Town of Franklin

Conservation Commission

Re: 1199 West Central Street – Garelick Farms
MassDEP File No. 159-1322
Notice of Intent Peer Review #2

BETA Group, Inc. (BETA) has reviewed revised documents and plans for the project entitled ***Garelick Farms Flood Resiliency Improvements*** (the Project), located at ***1199 West Central Street*** (the Site) in Franklin, Massachusetts. This letter is provided to present BETA's findings, comments and recommendations.

C-102

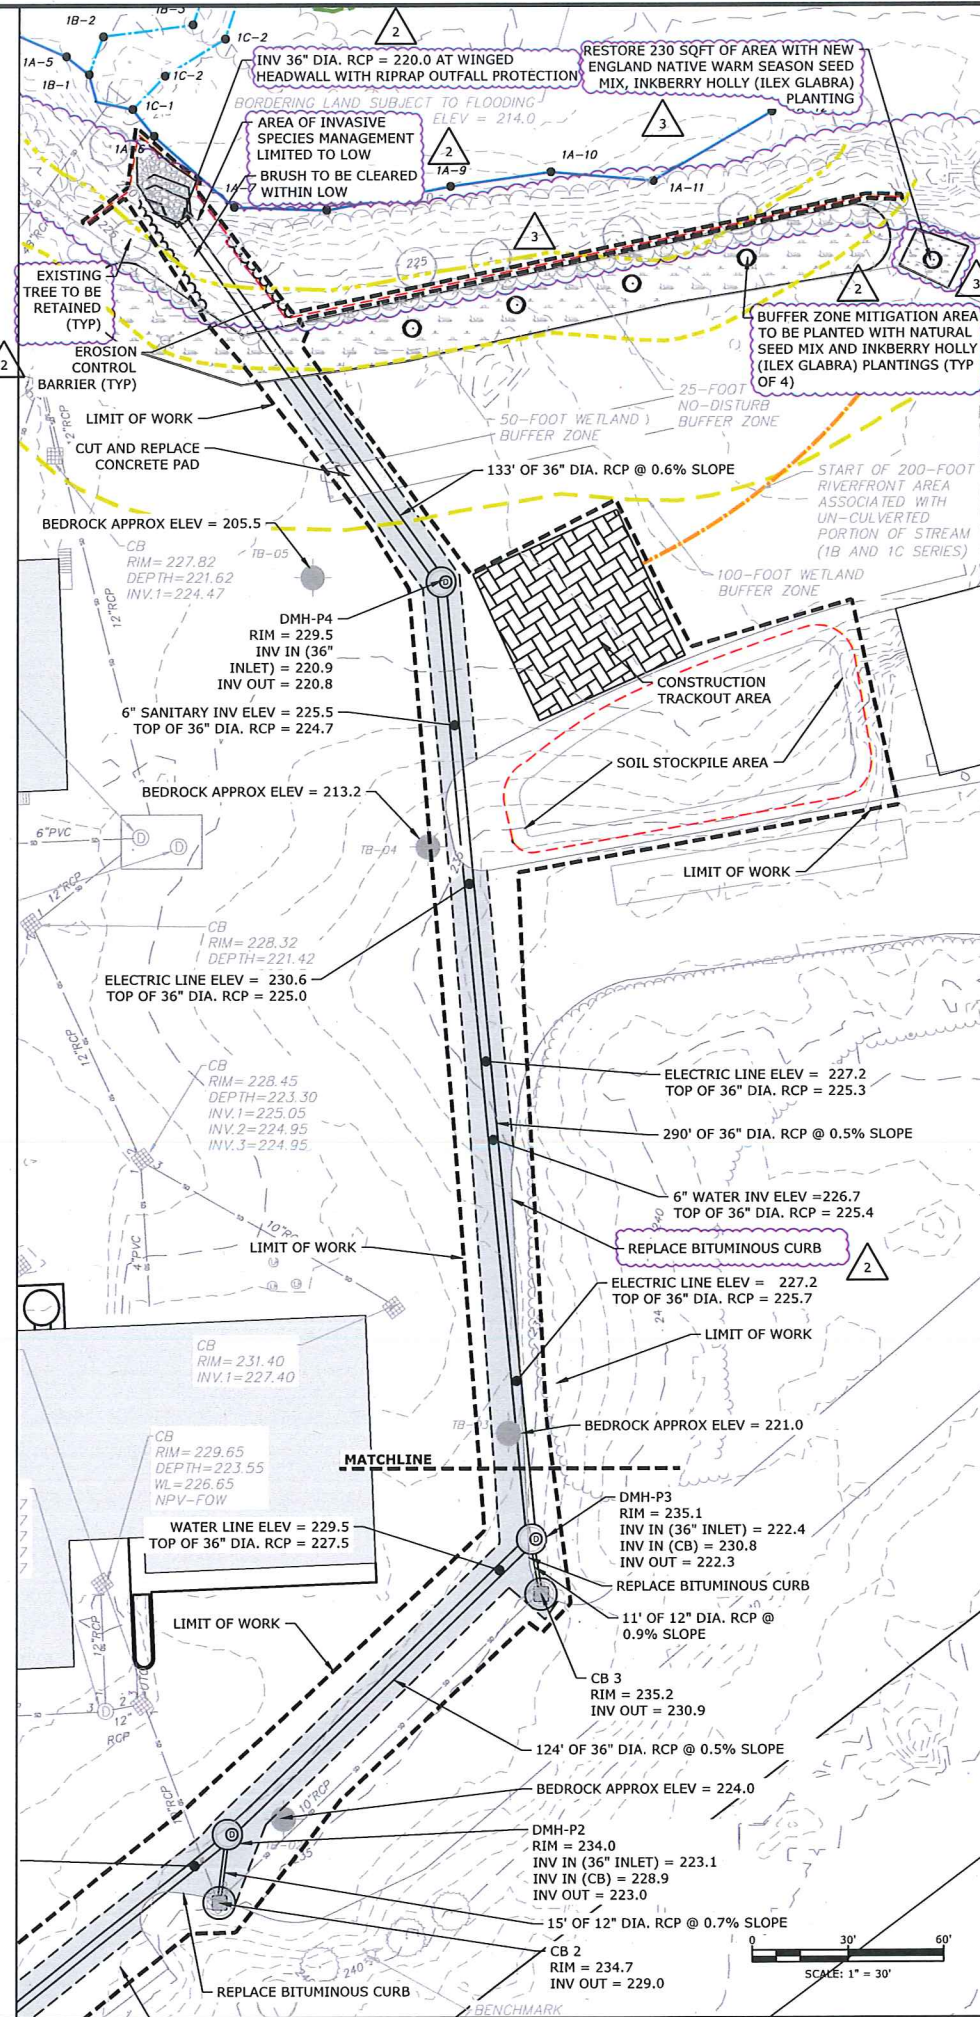
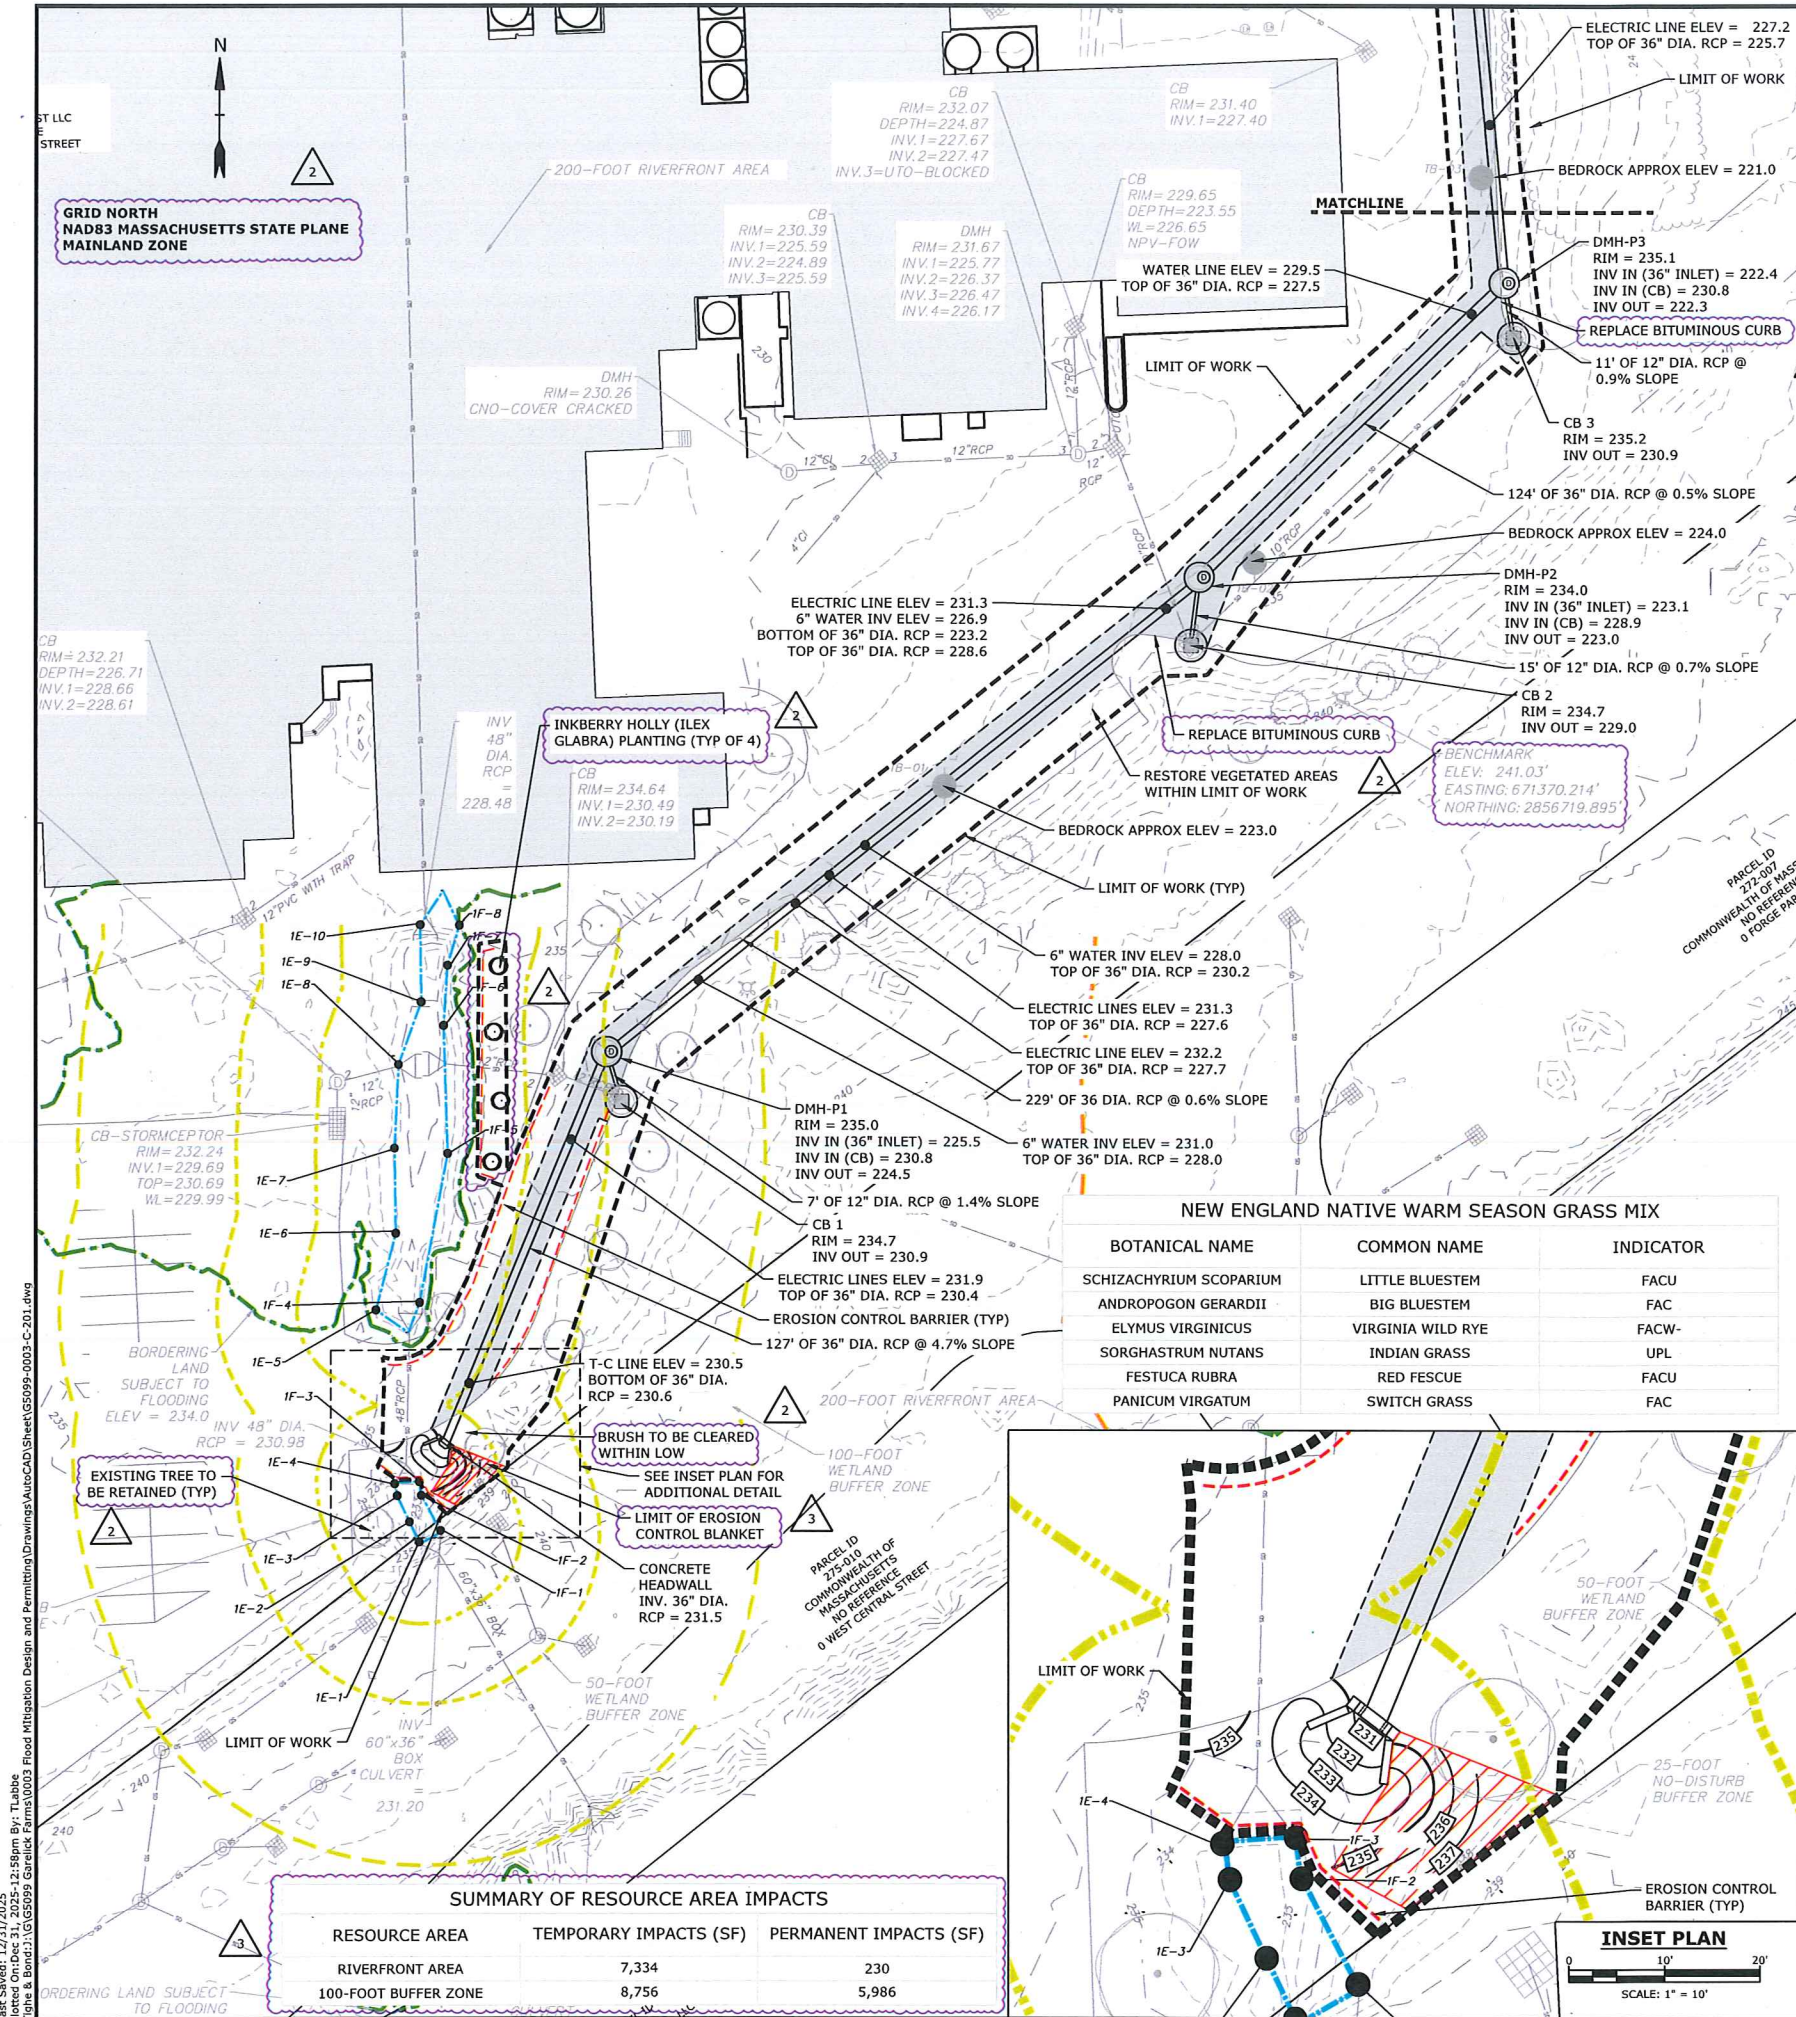
- b. Existing and proposed vegetation referenced in Bylaw Regulation Section 7.18.1.5 and 7.18.1.6 should be included on the plans, including individual trees/shrubs with a diameter greater than 1" proposed for removal. It is BETA's understanding that the Commission generally increases the size threshold for tree location based on the Project and therefore defers to the Commission on this matter. The existing and proposed tree line should be shown, and the proposed trees located along the limits of trenching should be qualified as being either removed or retained.

BETA2: Comment remains. The existing/proposed conditions tree lines are not depicted along the northern portion of the Site adjacent to the 1A Wetland Series where trees are present. The existing conditions plan appears to show a tree line in this area, but it does not encompass the locations of the individual trees that are depicted. The site plans depict a tree line in this area with a proposed conditions line weight, but it does not appear to correlate with the proposed clearing for the headwall. The tree lines should be revised as appropriate.

- W5. The limit of existing pavement and vegetated shoulder should be labeled on the plans adjacent to the location where work is proposed.

TB: Labels have been added to the Site Plans for the limits of existing pavement and vegetative shoulders. See sheet C-102.

T&B2: The existing/proposed tree lines have been added to the project plans in the area of the proposed drainage pipe and outfall installation. A note has been added on sheet C-102 to indicate that brush will be cleared within the limit of work in the area. The proposed condition tree line referred to in BETA's second round review comment appears to be the revision cloud used to indicate changes throughout various iterations of plan sets. To clarify the difference, revision clouds have been changed to purple.

C-501

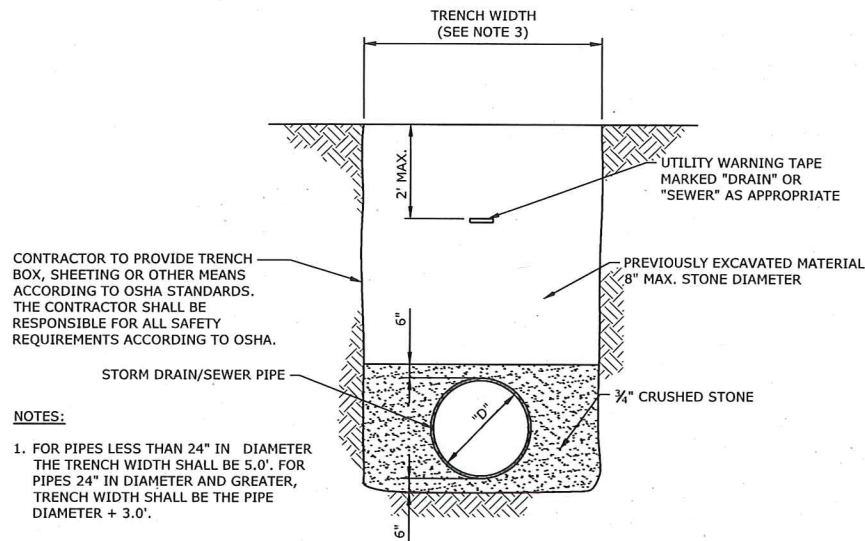
BETA2: BETA defers to the Commission on the approval of the use of straw wattles as erosion controls, as they have discouraged their use in recent years. The use of silt fence and hay/straw bales is referenced within the soil stockpile detail on page C-501 within Section 3.3 of the O&M Plan and should be revised accordingly.

- SW4. Recommend providing a detail for the replacement of curb on site.

TB: A detail for the replacement of curbing has been added to sheet C-501.

T&B2: The detail on sheet C-501 has been revised to indicate the use of compost filter tubes, and the O&M Plan has been updated to remove references to straw wattles.
